National Committee on **Uniform Traffic Control Devices**

National Committee on Uniform Traffic Control Devices (NCUTCD) Recommended Changes to Proposed Text for 11th Edition of the MUTCD Docket Number: FHWA-2020-0001

NPA MUTCD Section Number: Chapter 4H

CHAPTER 4H. BICYCLE SIGNALS

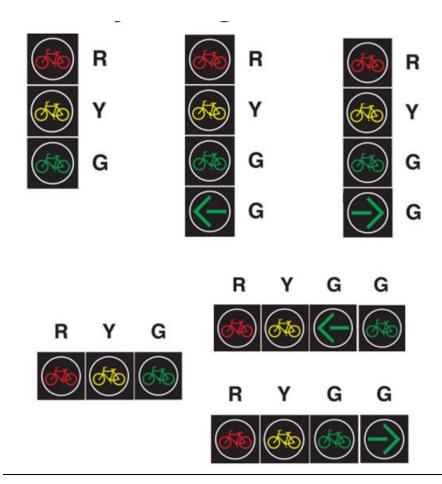
Figure 4H-1 Comments: NCUTCD recommends adding examples of 4-section bicycle signal faces in both vertical and horizontal orientations including left-turn or right-turn GREEN ARROW indications to indicate a protected turning movement for bicyclists, and adding an example of a 3-section horizontally oriented bicycle signal face.

If a bicycle turn movement is not in conflict with any other movement, a four-section bicycle signal face capable of displaying the following signal indications may be used: RED BICYCLE, YELLOW BICYCLE, GREEN BICYCLE, and left-turn or right-turn GREEN ARROW. [add to address bicycle signal indications with arrows]
